SECTION 2 Block 02_Roof Plan

FOR FULL SUMMARY OF PROPOSED CHANGES SEE SECTION 1.

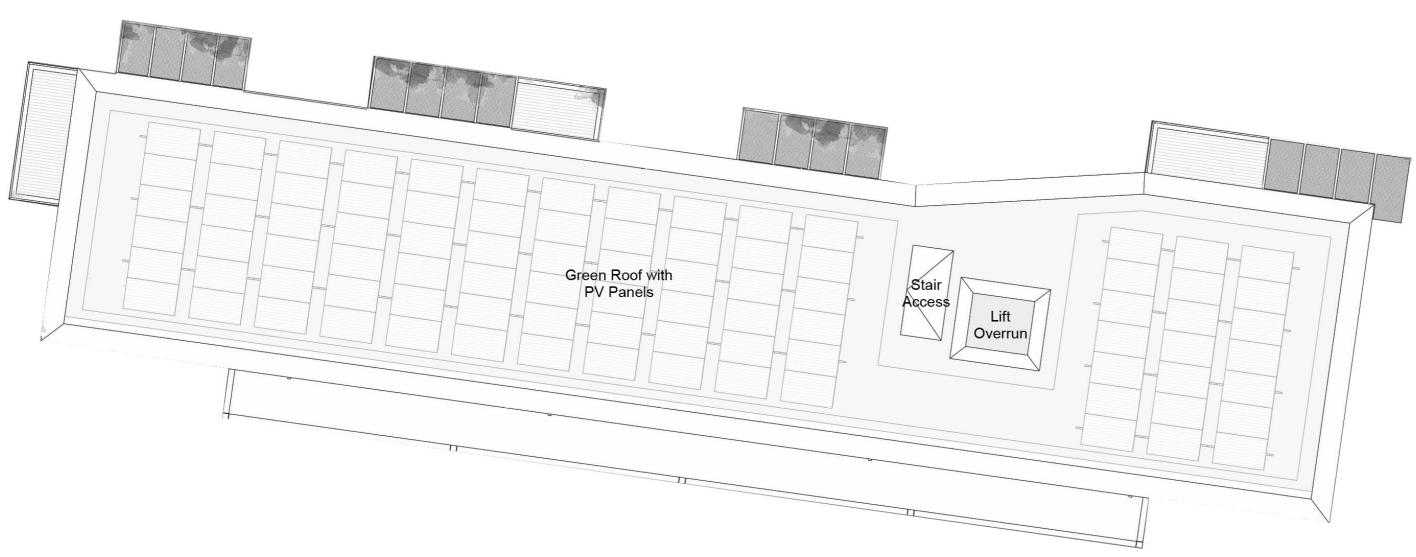
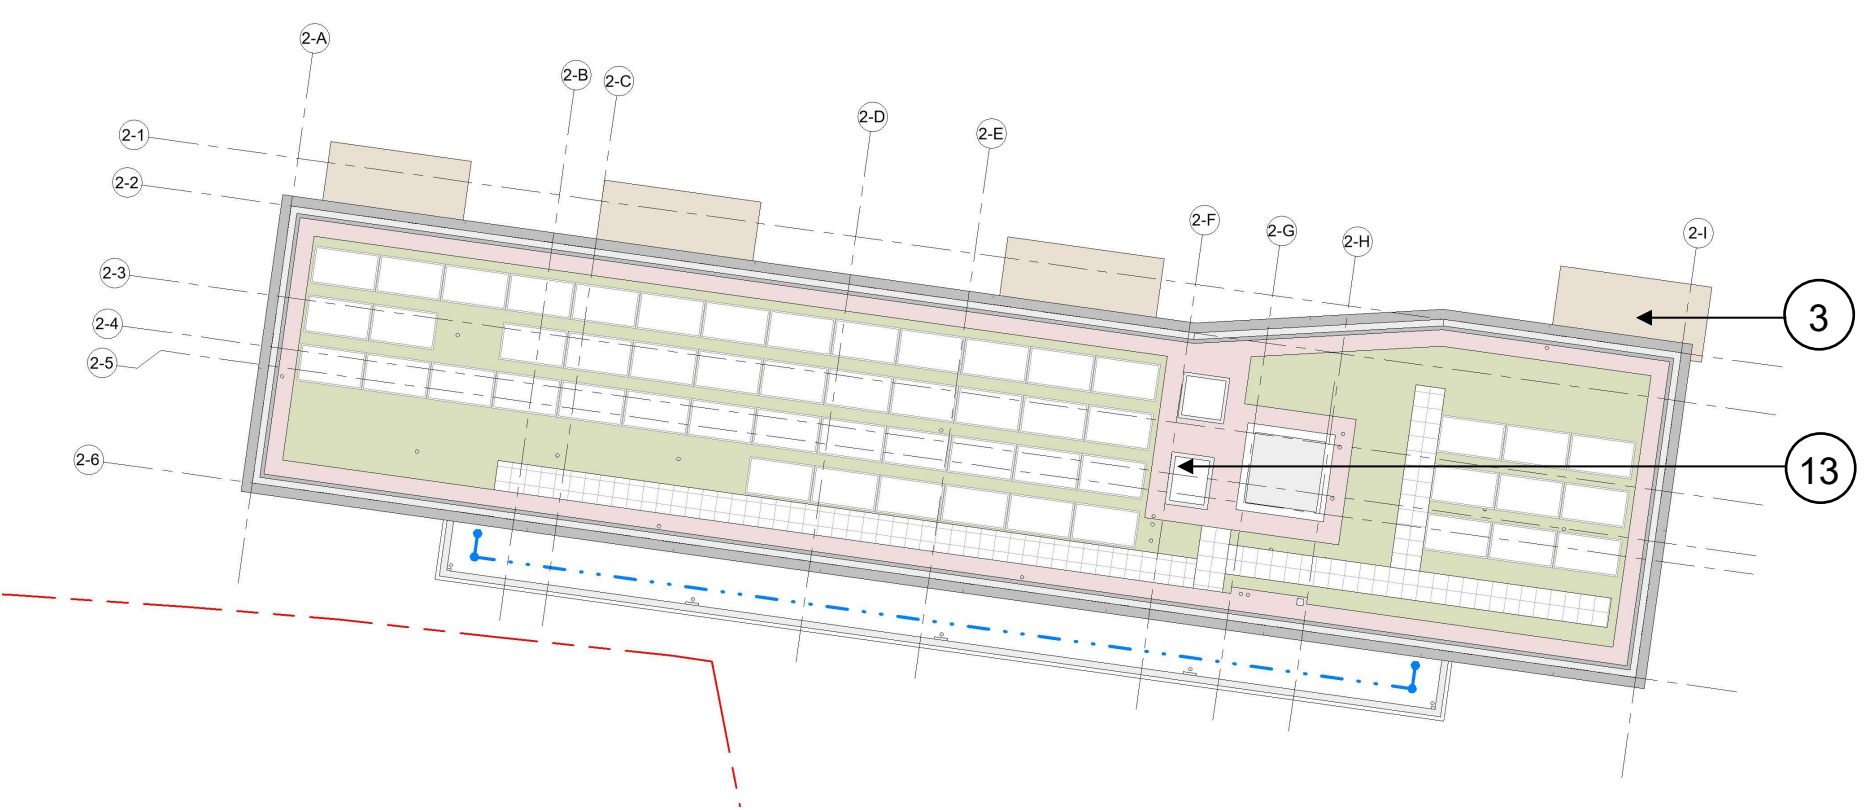
- 3. Corner bolt-on balconies cantilevered reduction.
- 13. Roof AOVs on top of stair core and lift lobby added.
